TECHNICAL BULLETIN

Rough Idle/Engine Misfire – New Spark Plug Wires and Routing

18-43

MODEL XJS Range (V12) and XJ12 DATE 11/94

Route the new wires as shown in Illustration 1.

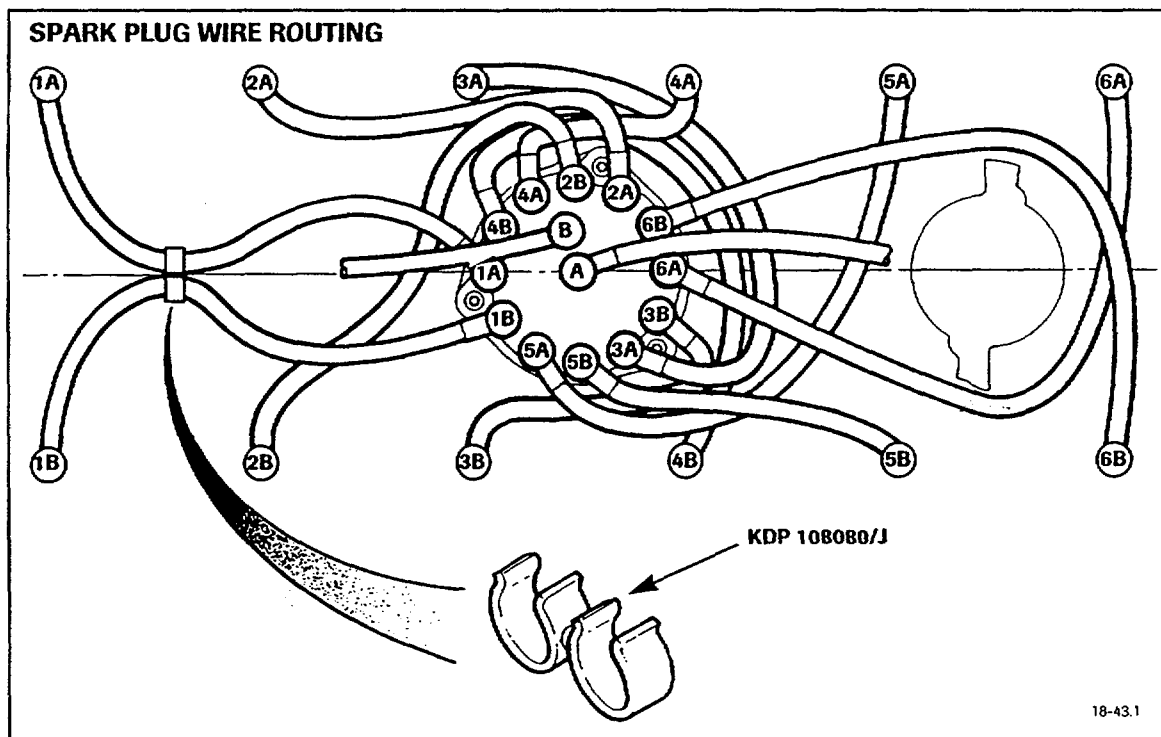
Rough idle and engine misfire conditions that develop after approximately 20,000 miles may be caused by high voltage leaks between the spark plug wires and cylinder head bolts.

New spark plug wire sets with revised routing were introduced in production from the following VIN numbers.

IMPORTANT: The clip (P/N KDP 108080/J) must be installed on the spark plug wires for cylinders 1A and 1B as shown in the illustration.

If customers complain of engine misfire or rough idle after approximately 20,000 miles on V12 vehicles produced before the VIN numbers shown above, replace the spark plug wires with the latest version.
